Access Compliance Report

Public Rights-of-Way

Intersection ID: 50592	Main Street: BENDING_BRANCH_RD	Cross Street: BRISTLEY_RD	Location: SW
ADA ID: 05B992EADC78	Ramp Type: Perp	Initial Pass/Fail: Pass	Overall Compliance: No
Severity Score: 5.25			
Codes/Mitigation Info/Possible Solution		Field Measurements/Component Compliance

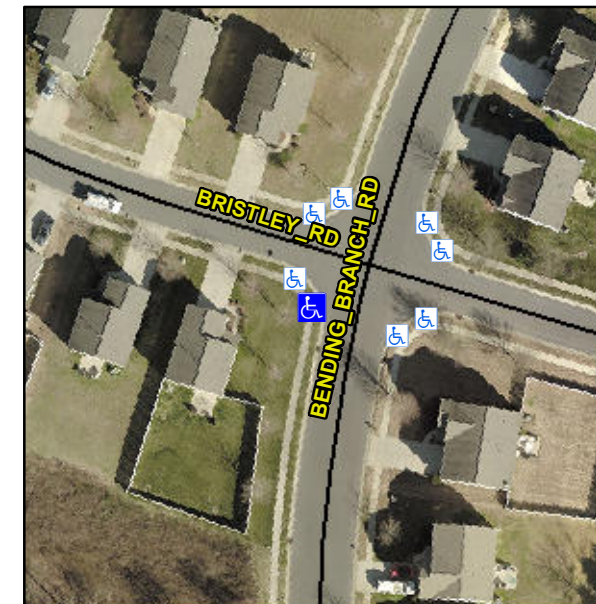
**Not Found, R304.5.3, R304.2.2-Perp,
R304.3.2-Para, R305.2, R304.5.4**

Compliance	Description	Data	Compliance	Description	Data
N/A	Ramp Length (in)	47.5	Yes	Ramp Slope (%)	5.3
Yes	Ramp Width (in)	48.0	No	Ramp XSlope (%)	3.9
N/A	Flare Type LT	Sloped	N/A	Flare Type RT	N/A
N/A	Flare Slope LT (%)	8.6	N/A	Flare Slope RT (%)	0.9
N/A	Flare Traversable LT?	No	N/A	Flare Traversable RT?	No
Yes	Landing Length (in)	48.0	Yes	DWS Provided?	Yes
Yes	Landing Width (in)	48.0	Yes	DWS Contrast?	Yes
No	Landing Slope (%)	3.0	Yes	DWS Length (in)	24.0
No	Landing X Slope (%)	6.5	Yes	DWS Full Width?	Yes
N/A	Landing Curb? (Y/N)	No	No	DWS Offset (in)	6.0
N/A	Shared Landing?	No			
Yes	Gutter Ponding?	No	No	Gutter Slope (%)	15.0
Yes	Gutter Lip Ht (in)	0.0	Yes	Gutter X Slope (%)	3.1
N/A	Painted X Walk1?	No	N/A	Painted X Walk2?	N/A
	X Walk 1 Direction	To E		X Walk 2 Direction	N/A
N/A	X Walk 1 Width (in)	N/A	N/A	X Walk 2 Width (in)	N/A
	X Walk 1 Slope (%)	0.9		X Walk 2 Slope (%)	N/A
	X Walk 1 X Slope (%)	3.4		X Walk 2 X Slope (%)	N/A

**Remove & Replace Entire Ramp.
Remove & Replace Gutter.**
